# UNITED STATES PATENT AND TRADEMARK OFFICE

APPLICATION NO.	FILING DATE	FIRST NAMED INVENTOR	ATTORNEY DOCKET NO.	CONFIRMATION NO.
09/802,982	03/12/2001	Stefan Karl	1200.473	6932

## Office Action Summary

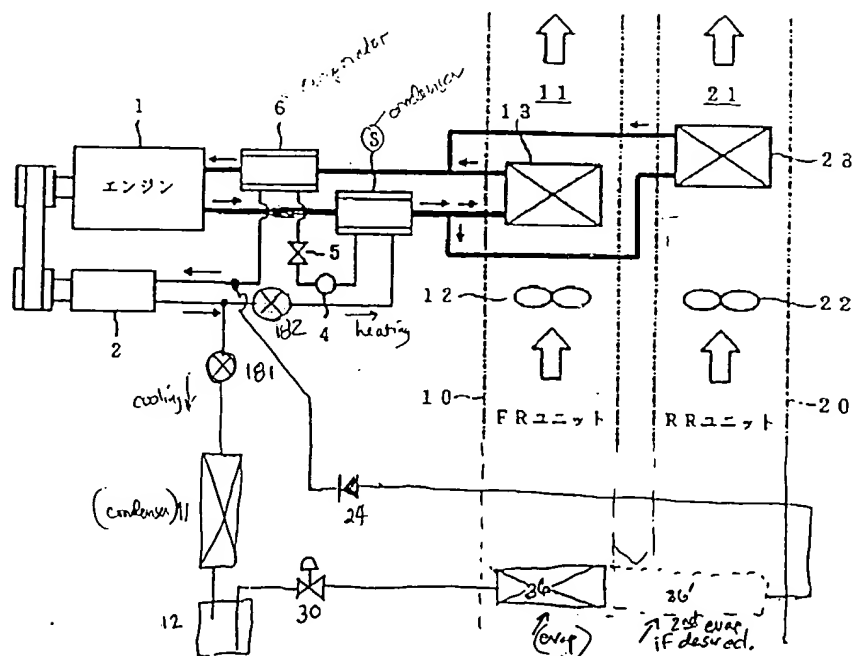
Claims 1, 2 and 10-14 are rejected under 35 U.S.C. 103(a) as being unpatentable over JA 10-76837 in view of Enomoto (Fig 8) and either Whalen or Momose (JA'134)

JA '837 shows a refrigerant system for beneficially increasing the heating effect of a liquid based heating system. It has no ability to cool the compartment in hot weather. The compressor 2 is known to be the most costly component of automotive refrigerant system.

Enomoto teaches in Figure 8 a refrigerant based heater circuit (182,13,37, 15) and a refrigerant based cooler circuit (181,11,12,30,36 and 24) connected in parallel across the output and inputs of the compressor 10.

To have added a refrigerant based cooler circuit (as described above) to JA'837 to give the capability of cooling in the summer as well as heating in the winter would have been obvious to one of ordinary skill in climates where air conditioning was needed to preserve occupant comfort. Appropriate valves (181,182) on the discharge

side of the compressor would be necessary to separately activate the heating and cooling systems. The modification is shown below.

Regarding claim 10, see element 24 in the sketch. Regarding claim 11, see elements 5 and 30. Regarding claims 13 and 14, note Enomoto shows an internal combustion engine and discloses as a substitute an electric motor (col. 5, last line).
